ADDENDUM NO. 1
TO CONTRACT DOCUMENTS FOR THE
ANDERSON DAM TUNNEL PROJECT
Project No. 91864005 Contract No. C0663

Notice is hereby given to Prospective Bidder that the Contract Documents are modified as hereinafter set forth.

19. **REPLACE** the following Sheet Codes as shown in ATTACHMENT NO. 2

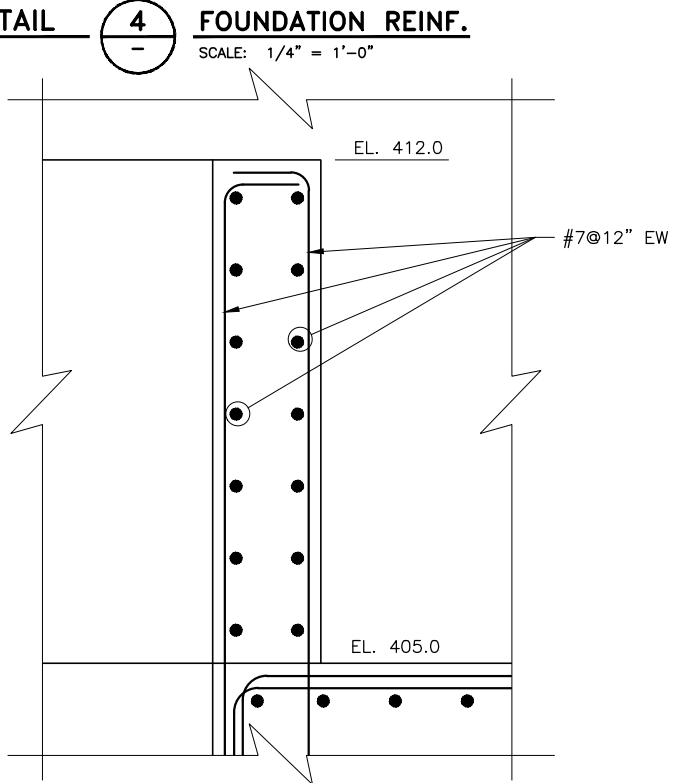
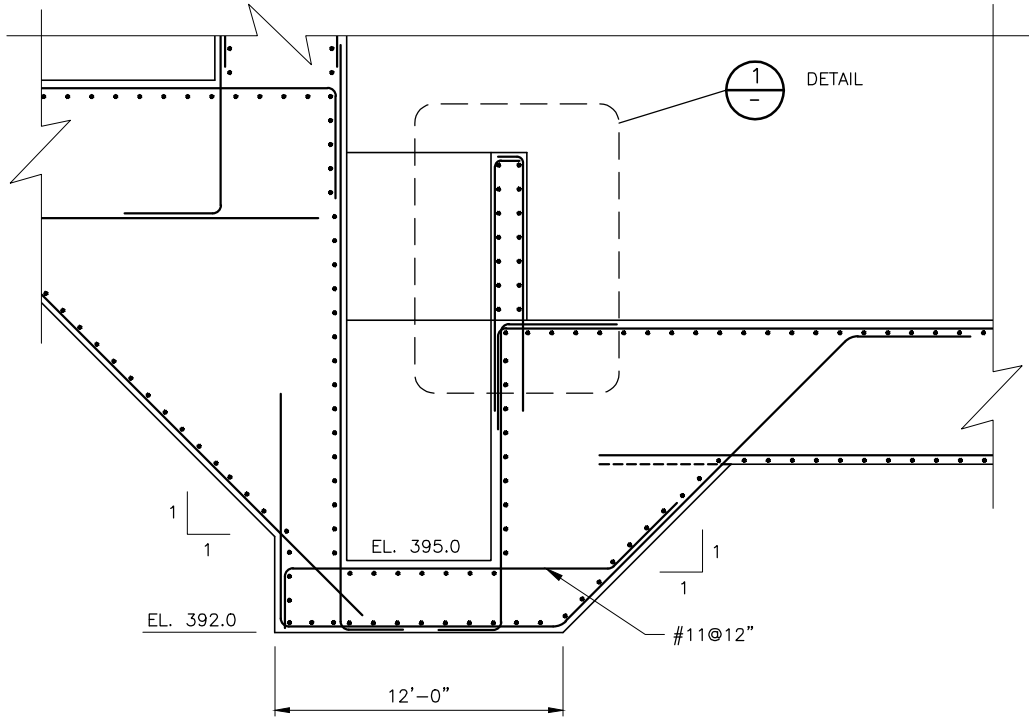
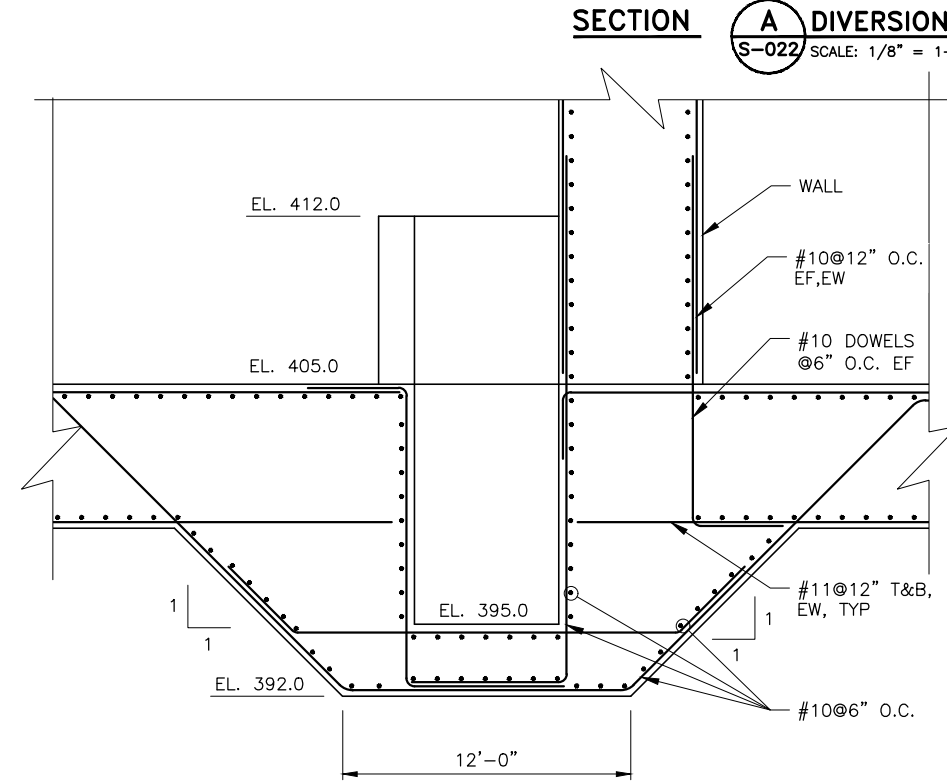
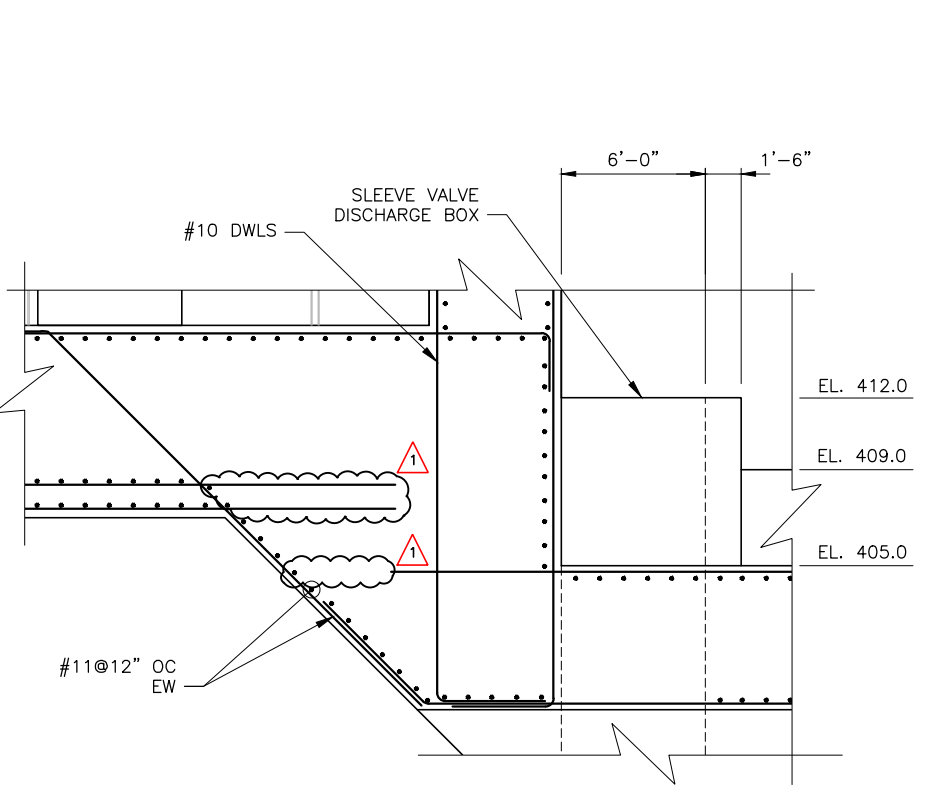
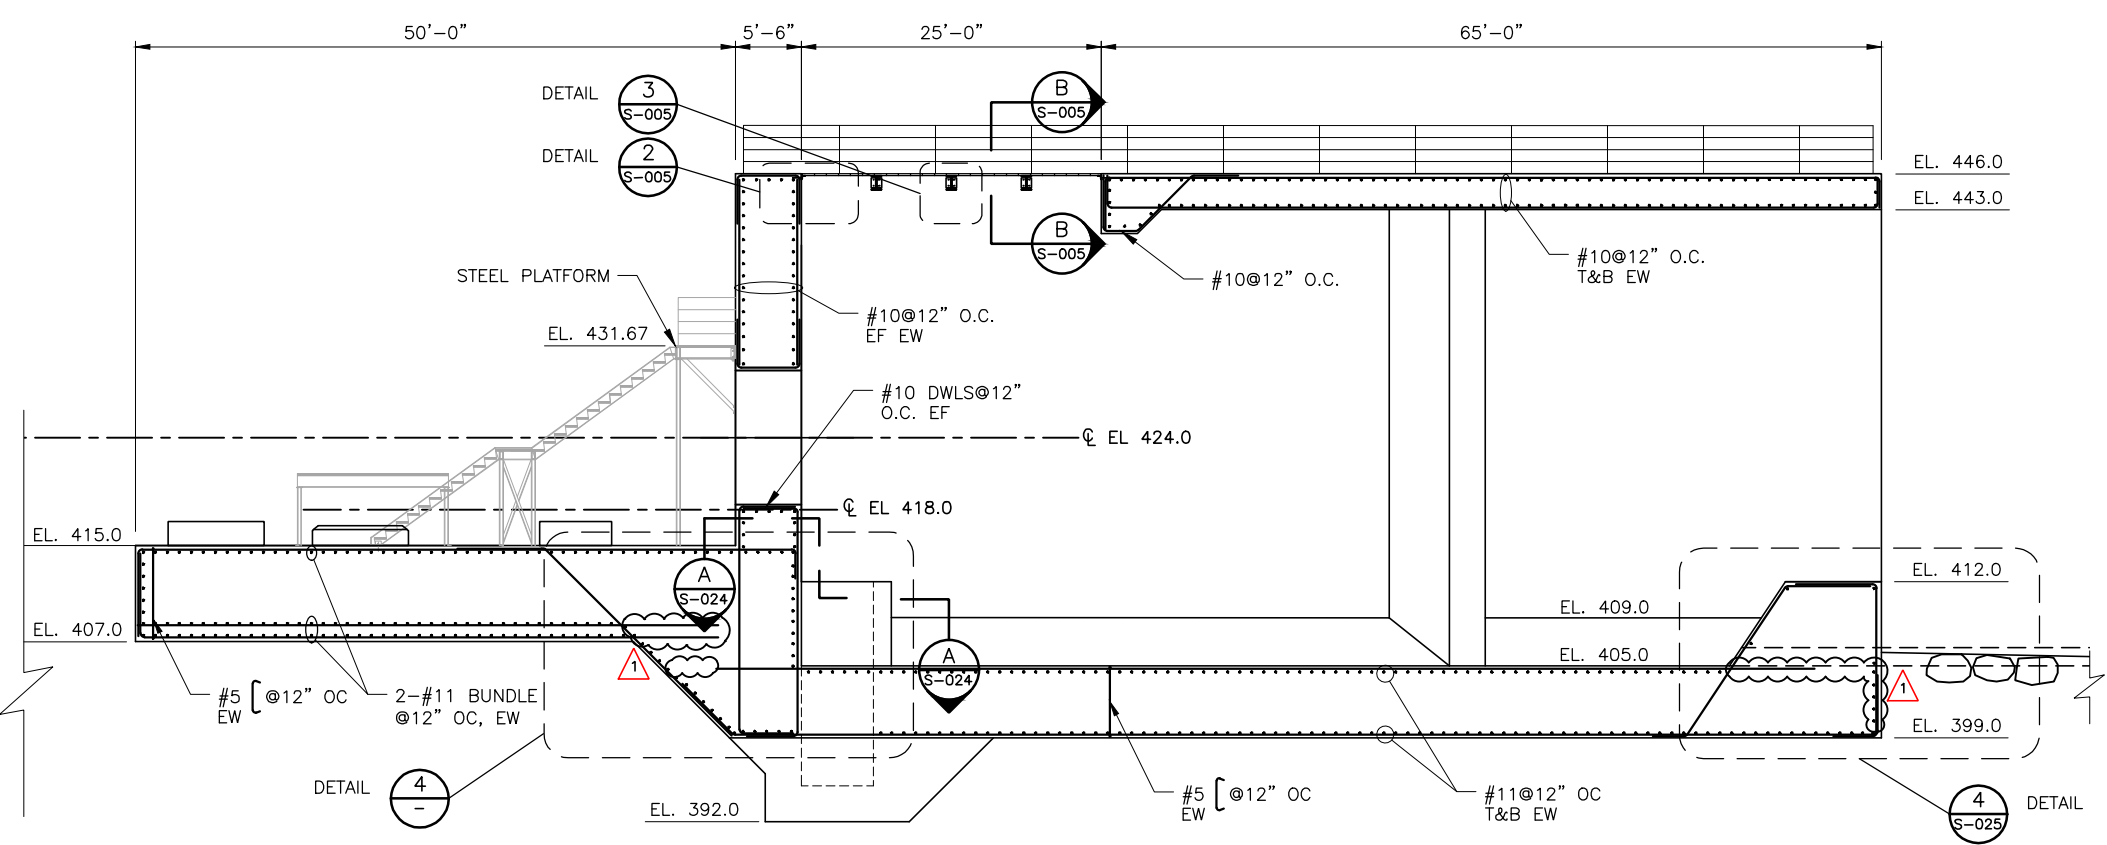
Section A on Drawing S-023 shows top mat reinforcing in the lower foundation slab (slab from Elev. 399 to Elev. 405) to be continuous all the way to the west end of the slab. Section C on Drawing S-024 shows no top mat bars in this slab between the interior faces of the exterior walls. This section is taken through the raised portion at the end that extends up to elevation 412. However, Detail 4 on S-025 indicates longitudinal and transverse bars in the top mat continuing through this area. Please clarify.

Section A and Detail 4 on S-023 show the bottom two mats of bundled #11 bar extending into the sloped transition area, but neither provide a dimension. How far past the break point do these bars extend?

REV	DESCRIPTION	DATE	APPR.	REFERENCE INFORMATION AND NOTES
1	1. REVISED REBAR (ADD. #1)	02/21	JWR	
ADDENDA DRAWING 02-15-2021 CEII - DO NOT RELEASE

Section C on S-024 is correct. Sheets S-023 and S-025 have been revised, included in item nos. 19(g) and 19(h), and Attachment No. 2 of Addendum No. 1.

S-023 has been revised, included in item no. 19(f) and Attachment No. 2 of Addendum No. 1

SCALE	PROJECT NUMBER
AS NOTED	91864005
VERIFY SCALES	SHEET CODE: 1
0 1" BAR IS ONE INCH ON ORIGINAL DRAWING IF NOT ONE INCH ON THIS SHEET, ADJUST SCALES ACCORDINGLY	S-024
	SHEET NUMBER: 88 OF 146

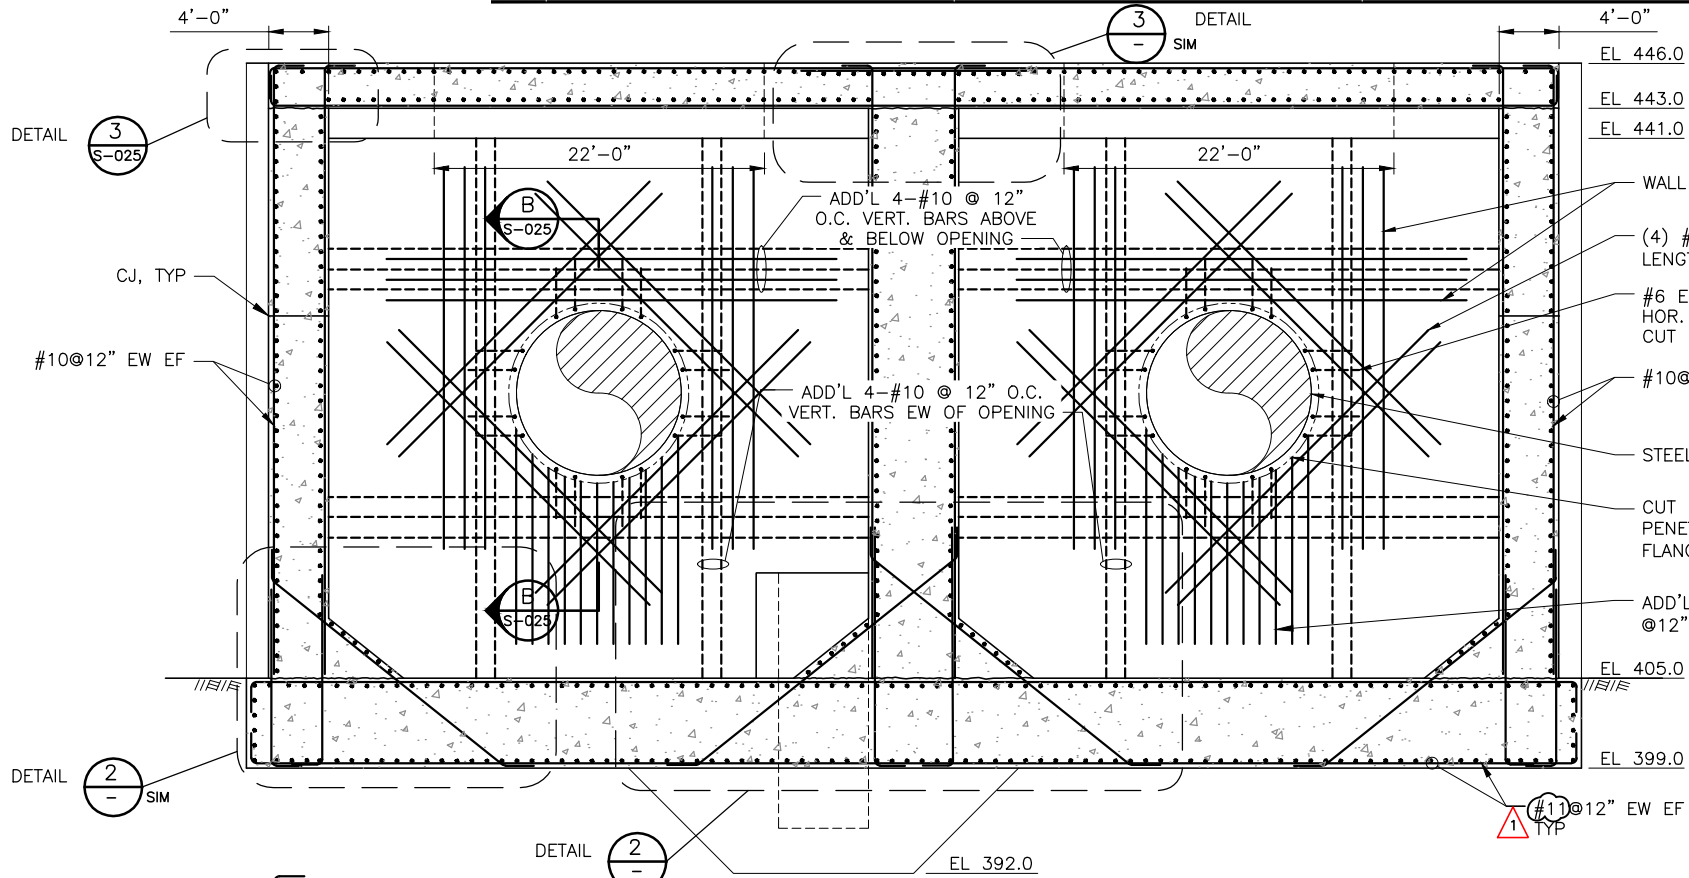
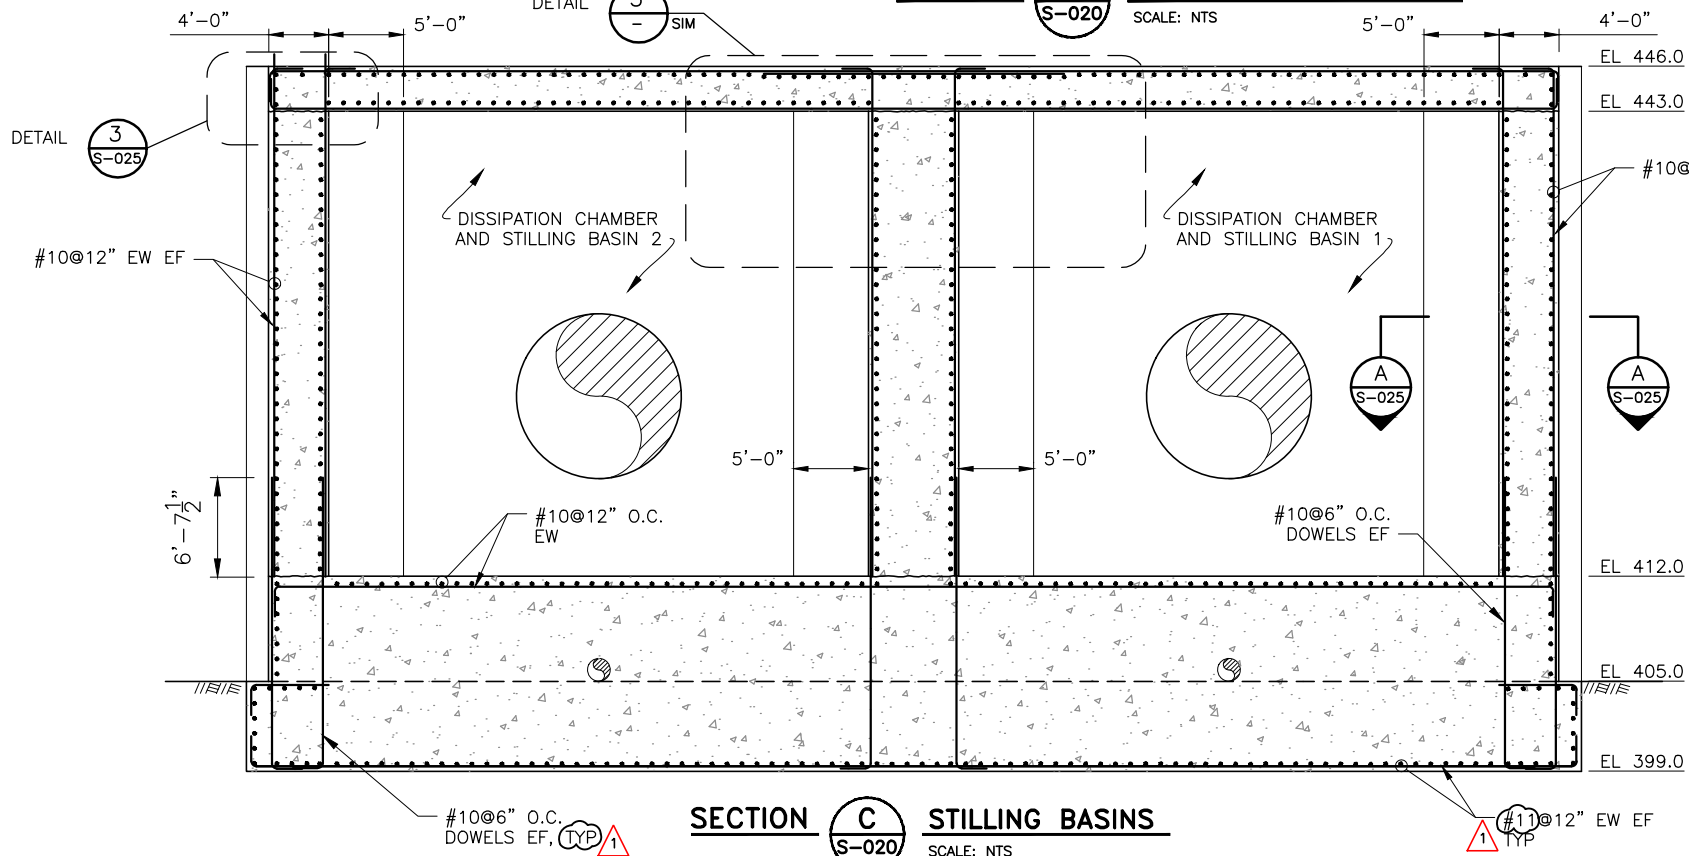
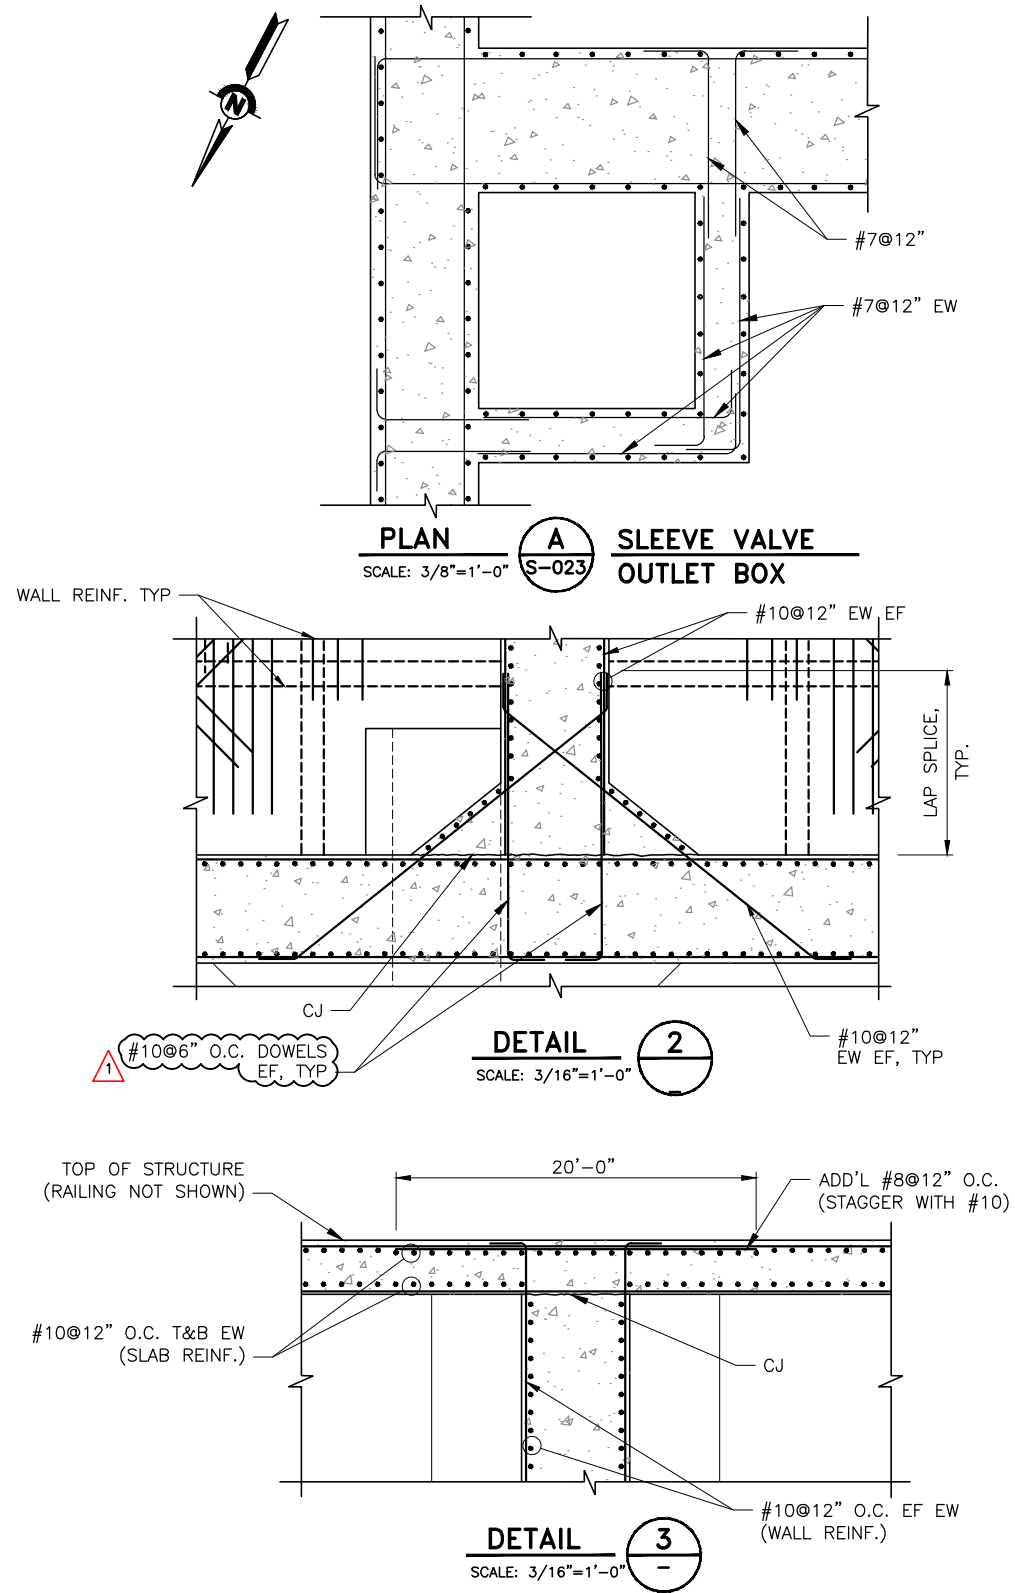
Section A on Drawing S-023 shows the lower foundation slab (slab from Elev. 399 to Elev. 405) to have #11 bars at 12" T&B EW. Sections B and C on Drawing S-024 appear to indicate #10 bars. Please clarify.

Section C on Drawing S-024 calls for 6" spacing on the #10 dowels coming out of the slab and going into the walls. Section B on this drawing does not call out a spacing. Do the dowels continue on 6" spacing, or is the 6" spacing only for the raised area at the end with dowels reverting to 12" spacing to match the vertical wall reinforcement?

REV	DESCRIPTION	DATE	APPR.	REFERENCE INFORMATION AND NOTES
1	1. REVISED REBAR (ADD. #1)	02/21	JWR

S-024 has been revised, included in item no. 19(g) and Attachment No. 2 of Addendum No. 1.

Dowels continue on 6" spacing. S-024 has been revised, included in item no. 19(g) and Attachment No. 2 of Addendum No. 1.

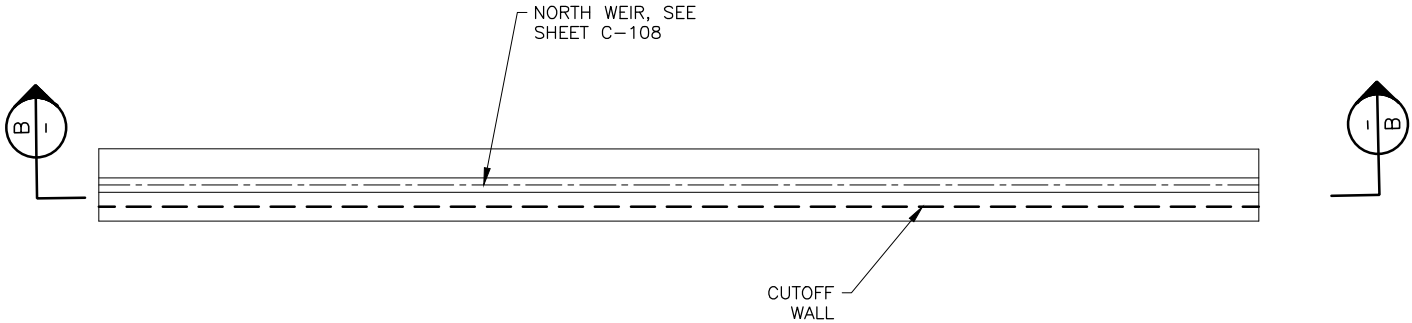
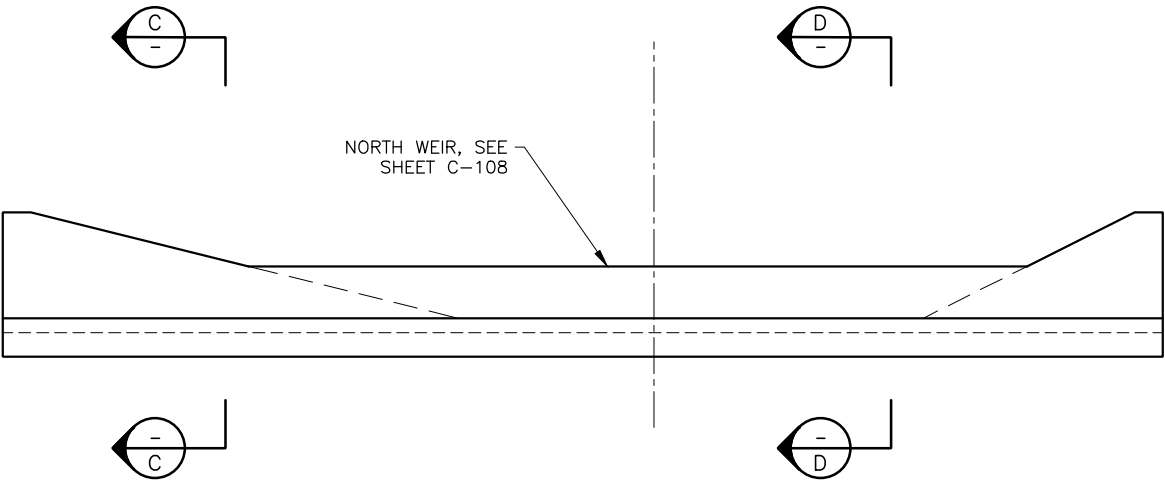
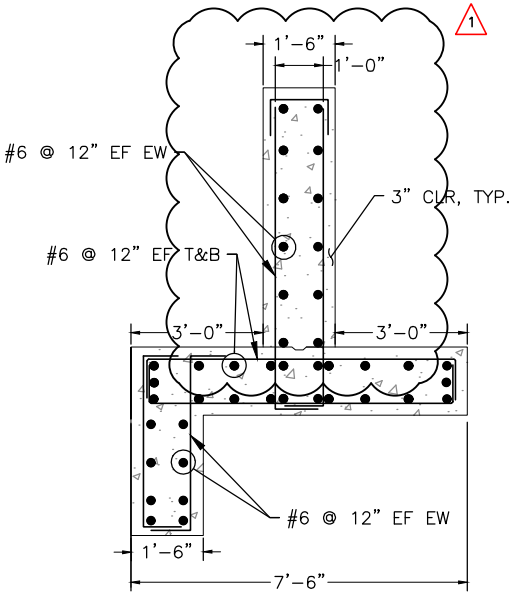
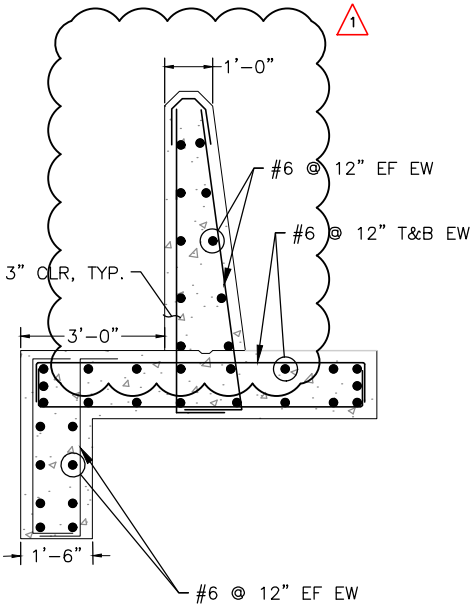
REV	DESCRIPTION	DATE	APPR.	REFERENCE INFORMATION AND NOTES	ENGINEERING CERTIFICATION	SANTA CLARA VALLEY WATER DISTRICT	PROJECT NAME AND SHEET DESCRIPTION:	SCALE	PROJECT NUMBER
1	1. REVISED WEIR CREST HEIGHT (ADD. #1)	02/21	JWR	URS 300 Lakeside Drive, Suite 400 Oakland, CA 94612 Tel: (510) 893-3600 Fax: (510) 874-3268	PROFESSIONAL ENGINEER CHRISTOPHER HAKES C 82873 STATE OF CALIFORNIA 1/18/21	 CHRISTOPHER HAKES 1/18/21	ANDERSON DAM TUNNEL PROJECT NORTH WEIR WALL DETAILS AND SECTIONS	AS SHOWN VERIFY SCALES 01" BAR IS ONE INCH ON ORIGINAL DRAWING IF NOT ONE INCH ON THIS SHEET, ADJUST SCALES ACCORDINGLY	91864005 SHEET CODE: 1 S-101 SHEET NUMBER: 101 OF 146
